I am writing to request that NMFS reject ExxonMobil's application for an Incidental Harassment Authorization (IHA) to take marine mammals as part of installing new conductor pipes at the Harmony Platform, Santa Ynez Production Unit, in the Santa Barbara Channel.

The Marine Mammal Commission, in consultation with its Committee of Scientific Advisors on Marine Mammals, has reviewed the application submitted by ExxonMobil Production Corporation (ExxonMobil), seeking authorization under section 101(a)(5)(D) of the Marine Mammal Protection Act (MMPA) to take small numbers of marine mammals by harassment. The taking would be incidental to conductor pipe installation activities to be conducted from August through November off the coast of California. The Commission also has reviewed the National Marine Fisheries Service's (NMFS) 30 June 2014 notice (79 Fed. Reg. 36743) announcing receipt of the application and proposing to issue the authorization, subject to certain conditions. The Commission provides the following recommendations and rationale.

RE: Comment on Takes of Marine Mammals for Pile Driving at Platform Harmony [RIN 0648-XD188]

**RE: Proposed Incidental Harassment Authorizatio

Figure 2: Latitude (Top) and number (Bottom) of blue whale satellite locations plotted by week. Locations used in the figure were from portions of blue whale satellite tracks that occurred within the U.S. Exclusive Economic Zone waters. The red line indicates the median value. Source: Irvine 2014

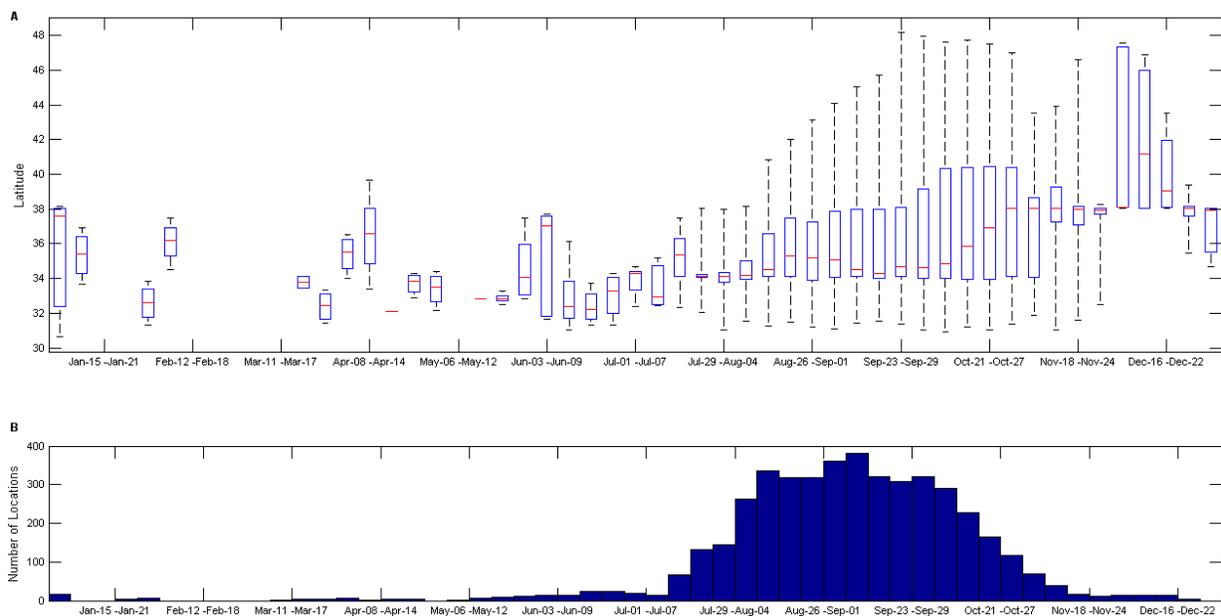
Between June and November, high densities of endangered blue whales spend time feeding on the abundant planktonic krill in the area of this project. See Figure 2. In fact, blue whales have developed a particular affinity for the area such that the Santa Barbara Channel hosts the world’s densest summer seasonal congregation of blues.
